ADDENDUM No. 2

June 7, 2017

Little Sisters of the Poor Lobby and Canopy Renovations
601 Maiden Choice Lane, Baltimore MD 21228

Project No: 17000.00

SECTION
CONCRETE PAVING SECTION
NOT TO SCALE

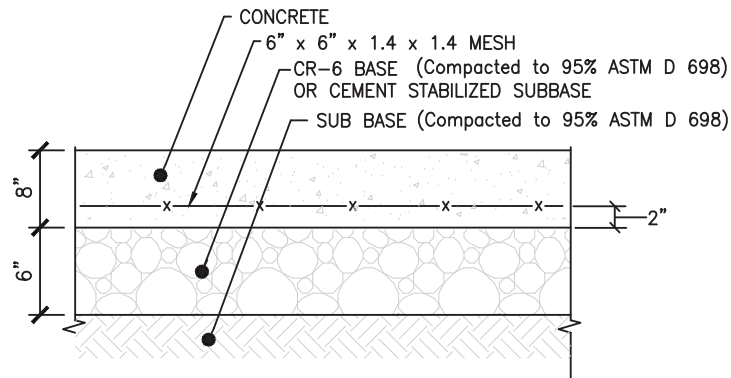
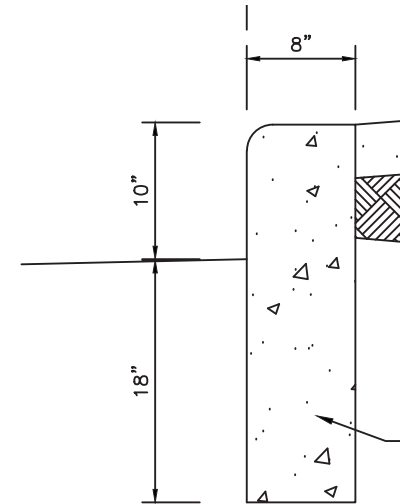
1. Civil Drawing 1 of 1:
 - a. See attached sketch C-SK-01 for new Concrete Paving Section.
 - b. See attached sketch C-SK-02 for revisions to the site plan (as described in Addendum 1)
2. Drawing AL-102: see attached revised drawing:
 - a. Roof details A1 & A2: the EIFS, including the top 7 1/8", shall be constructed per the EIFS specifications, there is no special substrate. Build-up profile as indicated.
3. Drawing AL-103:
 - a. See attached sketch A-SK-103-01 for updated Finish Schedule.
 - b. See attached sketch A-SK-103-02 for updated Finish Plan.
4. Drawing AL-104:
 - a. See attached sketch A-SK-104-01 for added footing information.

E-101

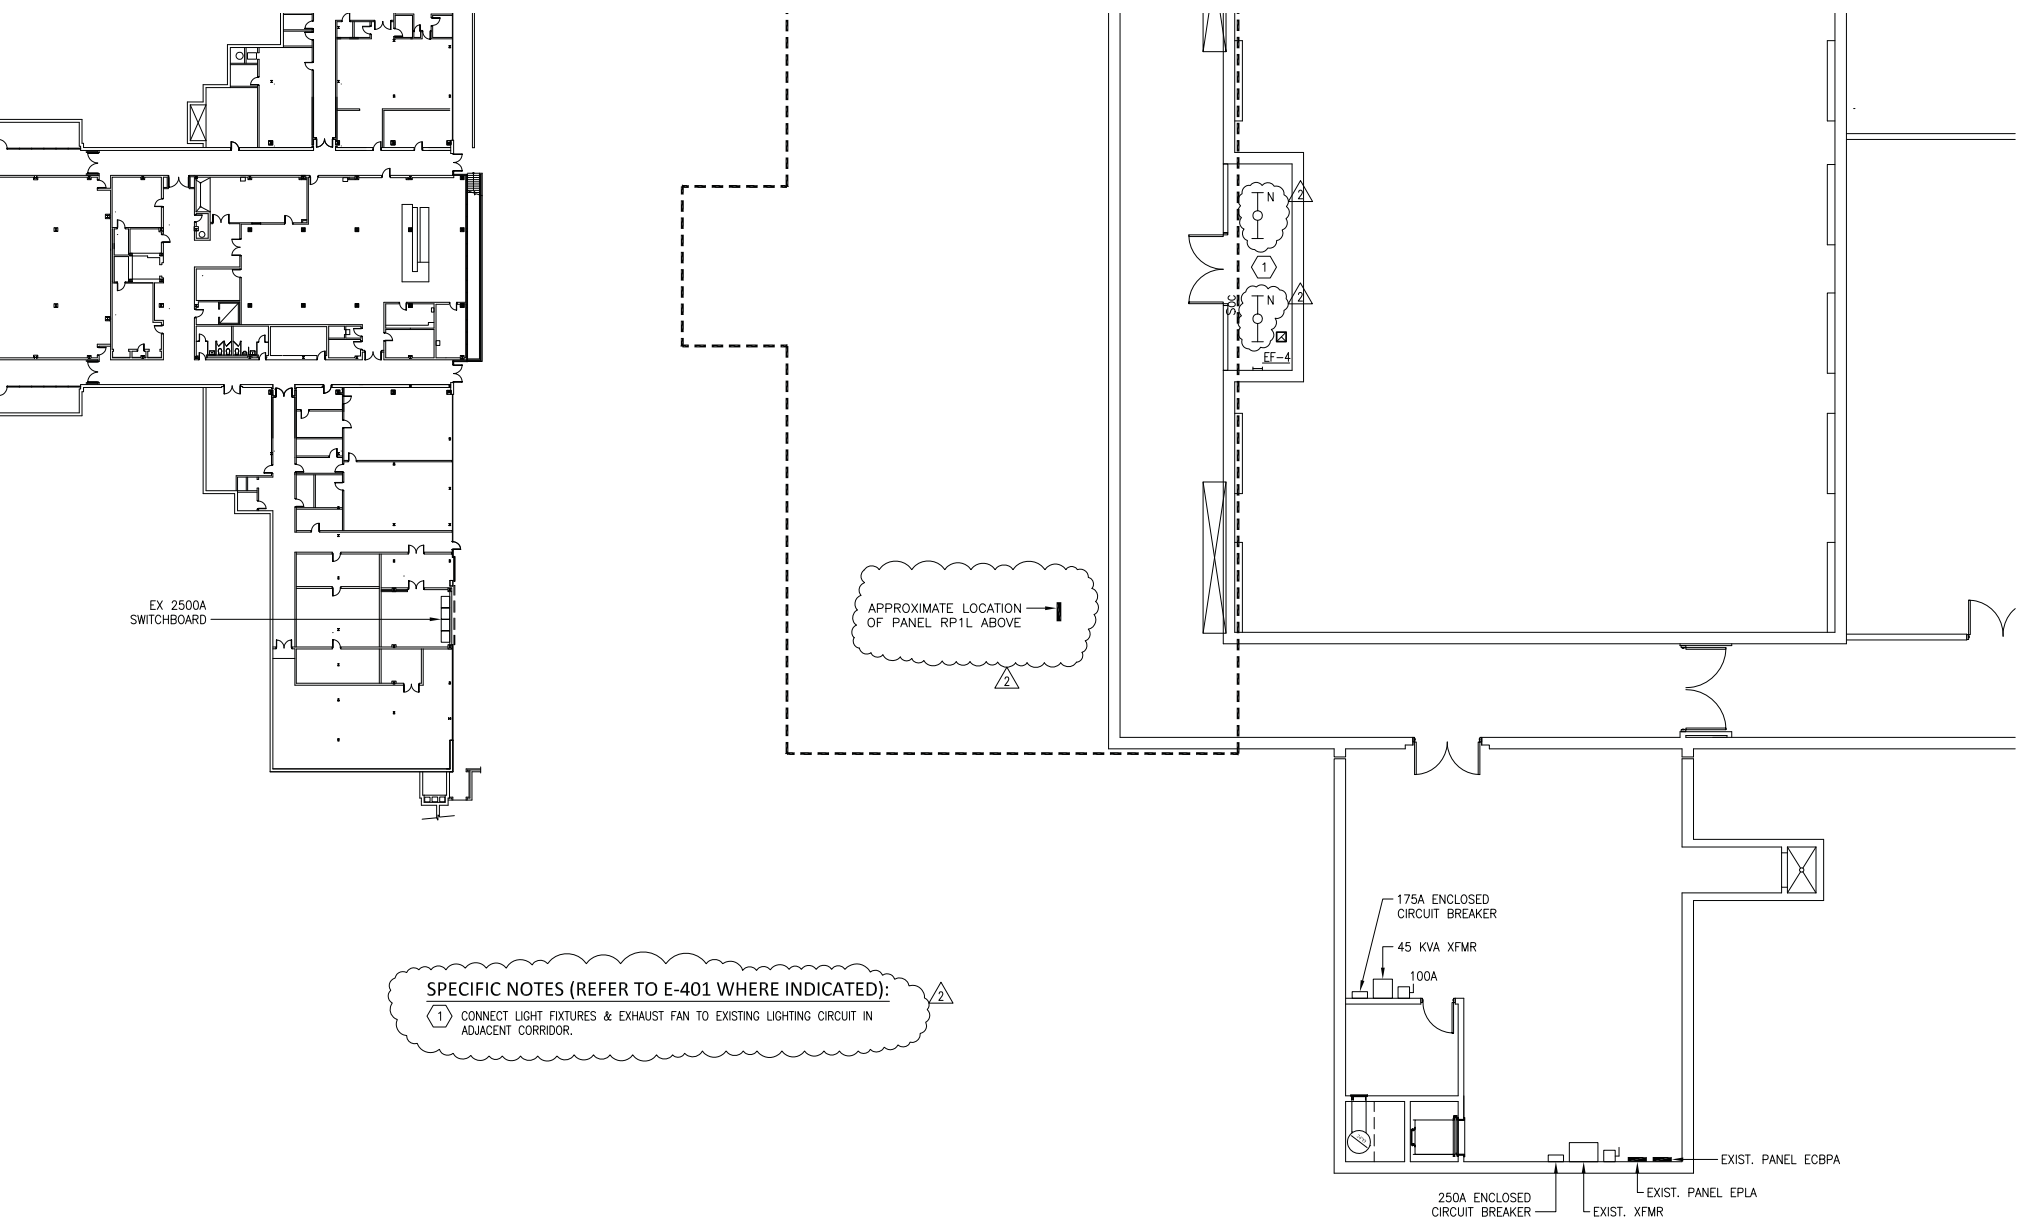
5. Drawing E-101:
 - a. First Floor Plan – Lighting: see attached revised drawing for added exterior lights and added lights to the emergency circuit.
 - b. First Floor Plan – Power: see attached revised drawing for added and/ or revised power for reception area equipment, added data/ telephone wiring and termination locations, exterior receptacles, connections for automatic door operators and emergency power outlets.
 - c. See changes to specific notes.
 - d. See added light fixture control device schedule.
6. Drawing E-401:
 - a. See attached sketch E-SK-401-01 for revisions to the Basement Part Plan - Power.
7. Drawing E-501;
 - a. See revised drawing for revised panel and light fixture schedules.
 - b. Details are for reference only.
